Report: Deficiency Report
Function: Test, Adjust, & Balance
Date: 09/30/2025
Completed By: National TAB

PROJECT
09-29-25 QT #1107 ANDERSON, SC

4123 CLEMSON BLVD

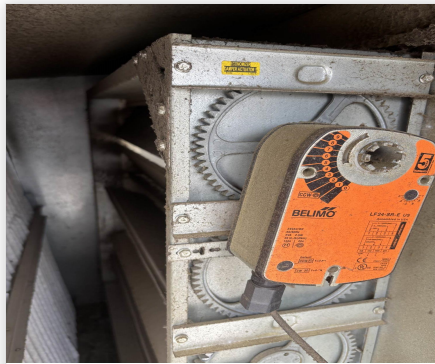
Issue Name : EF-1 speed controller
Description : The speed controller on EF-1 is not working, fan was left on high, above design.
Created By : National TAB **Assigned To :** National TAB - Brianna Biggs
Status : Open
Priority : Medium **Asset Tag :** EF1
Originated Date : 09/30/2025 - Christian Moller - National TAB
